**M9505A-03**

**S E R V I C E N O T E**

**M9505A - AXIe 5 slot Chassis**

**Chassis does not appear in the Agilent Connection Expert PXIO tree**

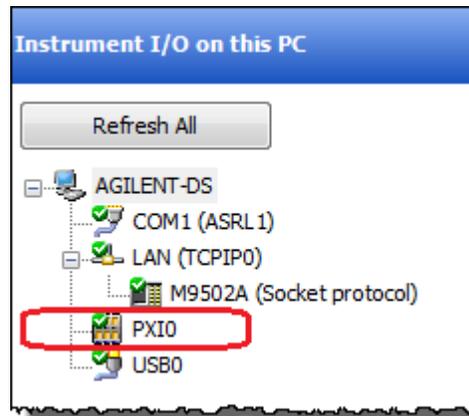
M9505A AXIe chassis that is connected through PCIe should automatically appear under PXIO tree in Agilent Connection Expert. It has been found that when using M9505A affected serial number, firmware, driver, and IOLS described above, the M9505A does not appear in the Agilent Connection Expert PXIO tree. See picture example below:

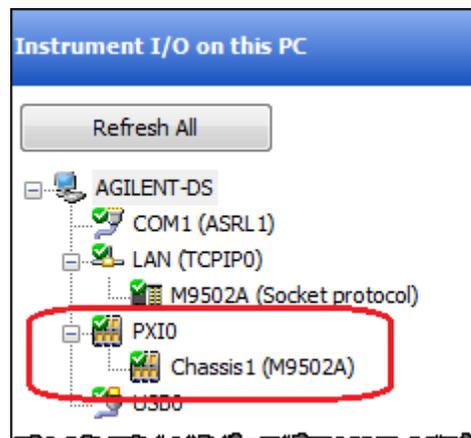
The chassis should automatically appear like this:

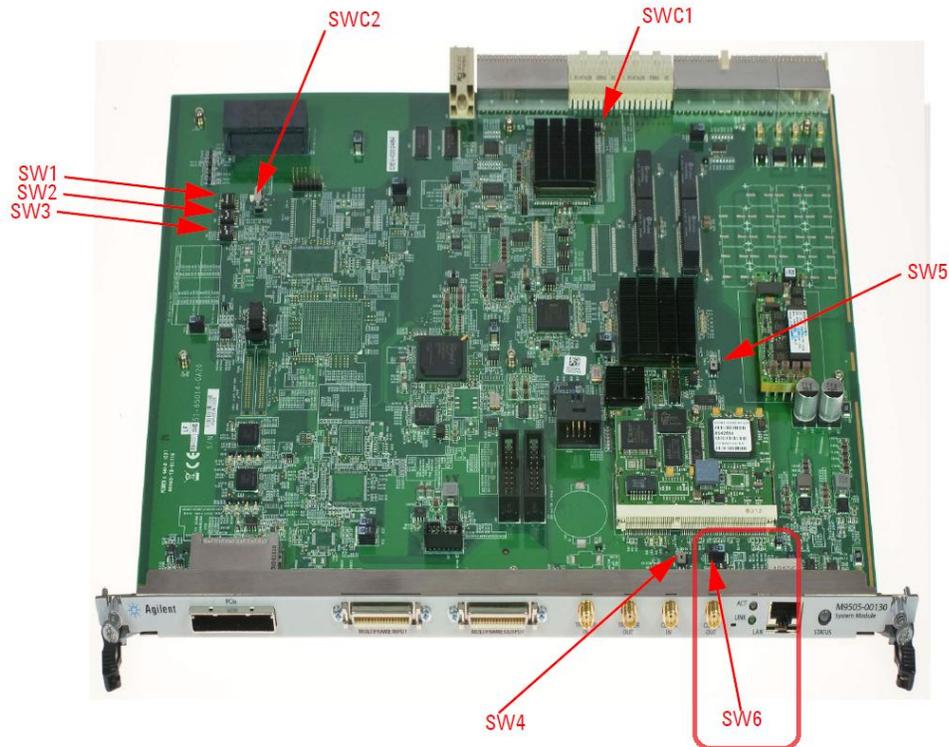
1. Power off the M9502A chassis.
2. Remove the M9536A embedded controller from the chassis if you have an M9536A installed.
3. Remove the M9505-00130 or M9505-00230 ESM from the chassis.
4. Locate the DIP switch 6 (SW6) on the ESM as shown in the figure below.

Reconfiguration of the chassis PCIe interface is needed to fix this issue. This can be accomplished by moving a particular DIP switch on the Embedded System Module (ESM), cycling power on the chassis, and then restoring the original DIP switch position. To reconfigure the chassis PCIe interface, perform the following steps:

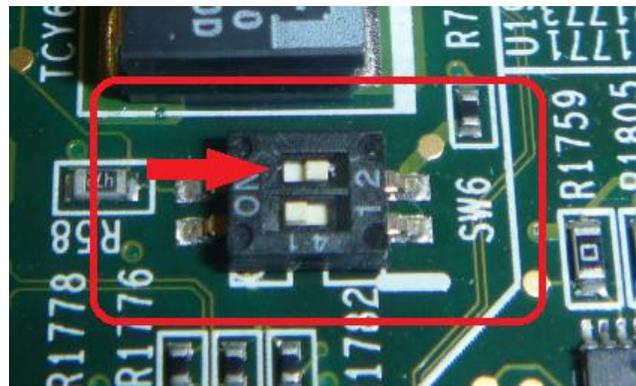
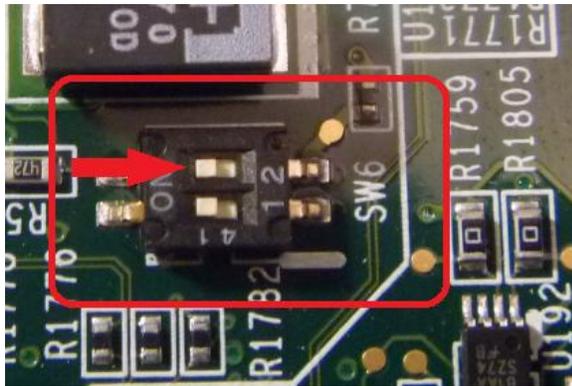
5. Locate the switch #2 of the DIP switch SW6 and change its position to the opposite position. If it is located on the left, switch it to the right. If it is located on the right, switch it to the left. See pictures example below:
